**BEFORE THE BOARD OF PATENT APPEALS
AND INTERFERENCES**

Application Number: 10/760,129
Filing Date: January 16, 2004
Appellant(s): BROWN ET AL.

EXAMINER'S ANSWER

* figure shows majority, more than 50% of graft surface is covered by another layer or fold. **FIG. 3A**

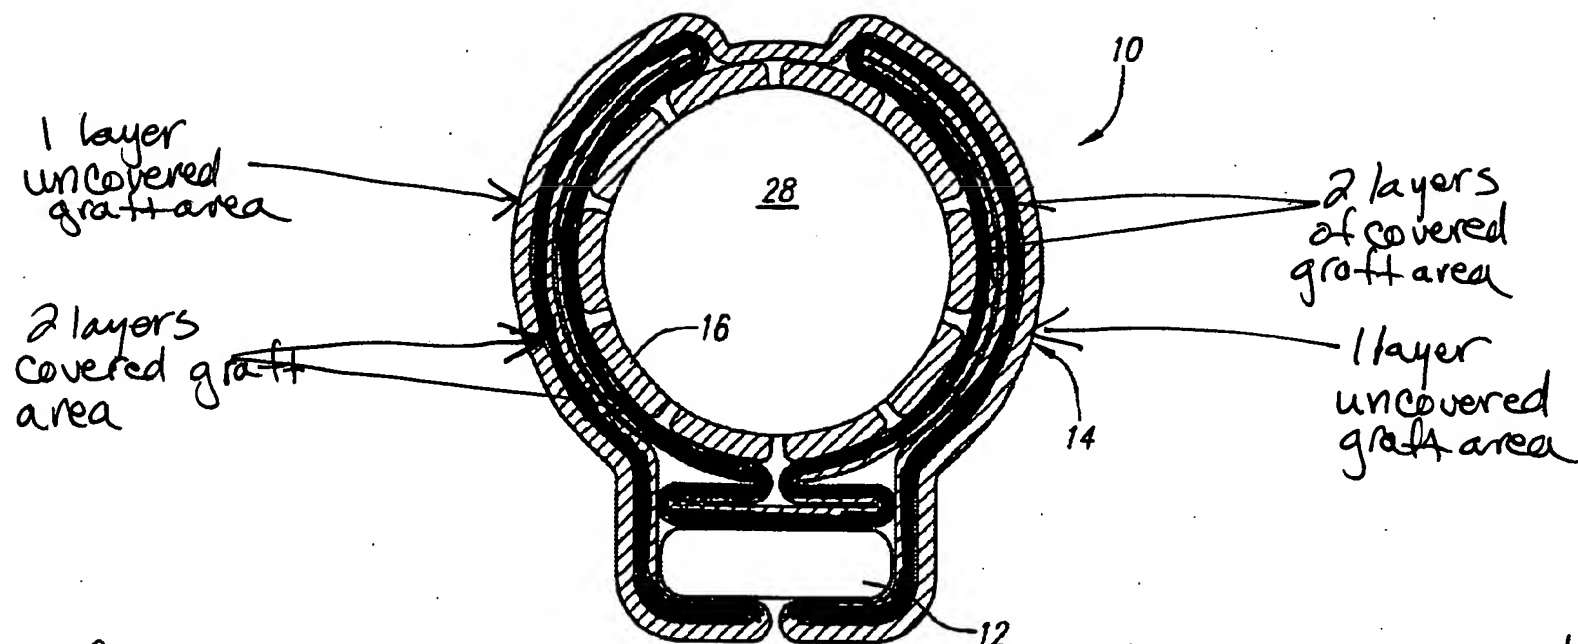
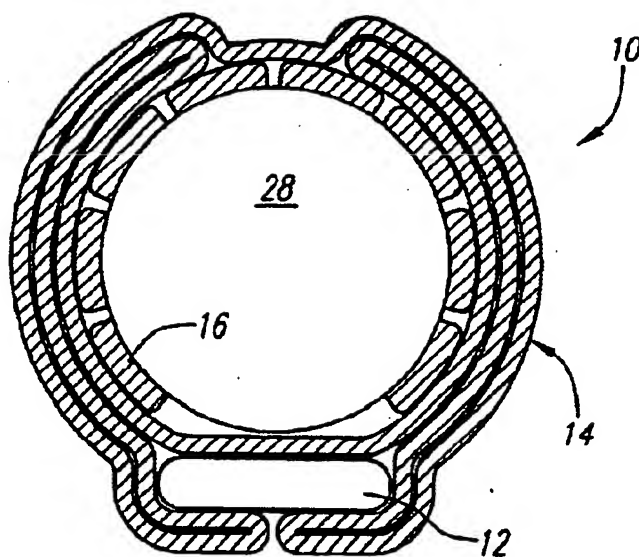
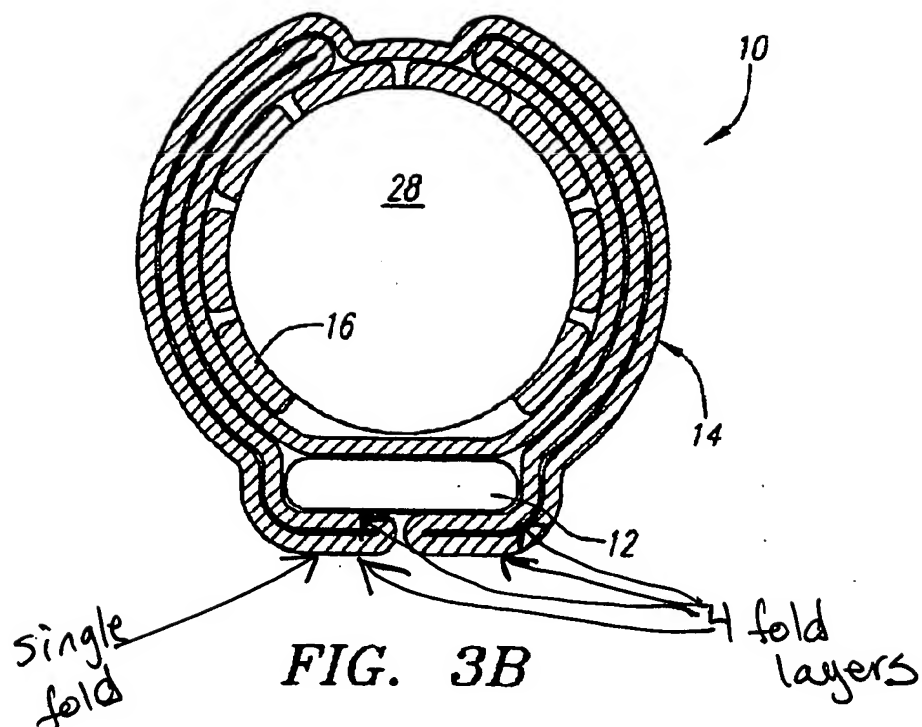
Referring to the dependent claims, Wolinsky discloses a single or multi folded section of graft material covering the sensor (figs.3A, 3B; attachment 1) or four layers of folds cover the sensor (attachment 1). Wolinsky discloses configuring the sensor such that it is perpendicular to a radius of the graft (see attachment 2). Wolinsky discloses configuring the graft to an H-shape (fig.3A may be considered an H-shape as it is similar to the configuration shown by applicant's own figures; see attachment 3).

FIG. 3B

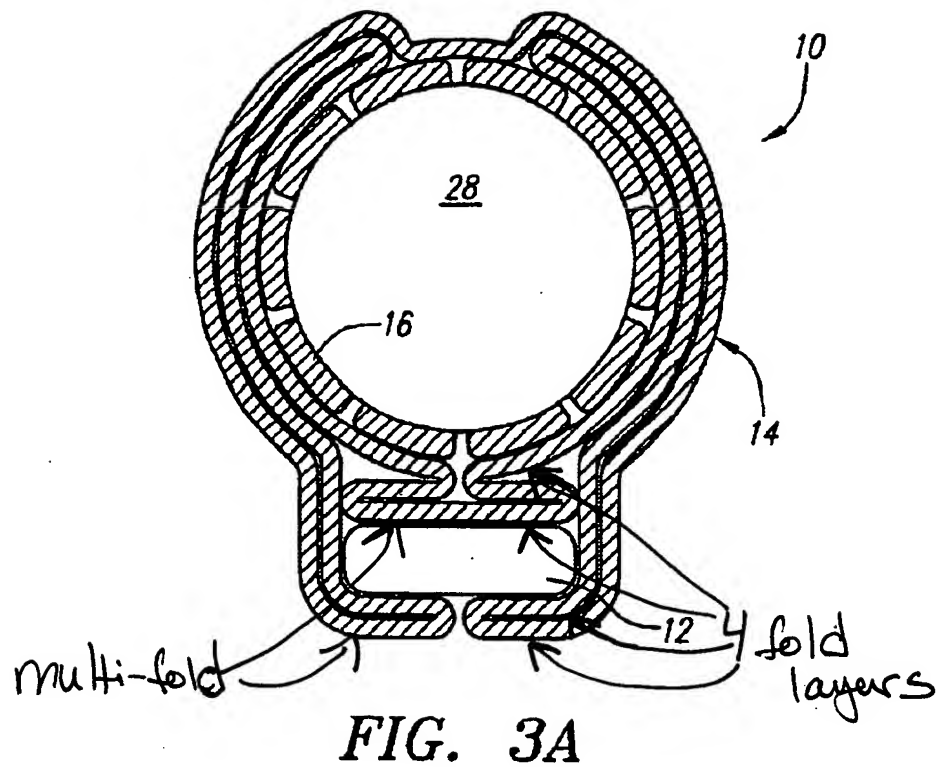
Wolinsky's graft having Quiachon's marker placement, inherently folds over the markers as well as the sensor since Wolinsky's graft is folded and overlapped several times, leaving less than 50%, more likely only 1/3, of the graft exposed (non-covered), see figs.3a, 3b and col.5, lines 38-48; and since Quiachon's markers are placed diametrically 180 degrees apart from one another, at least one line of markers inherently must be covered and protected (since they are 50% the distance of the graft circumference away from each other; and less than 50% of Wolinsky's graft is exposed).

FIG. 3A

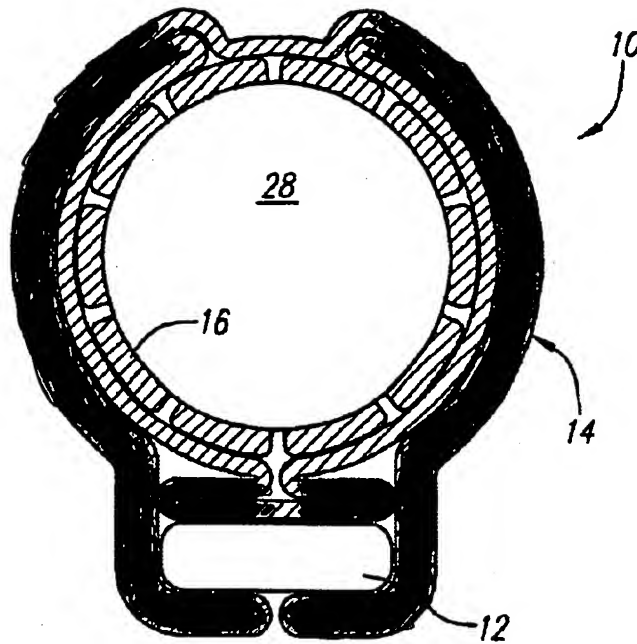
★ 4 legs of
"H" seen
shaded.
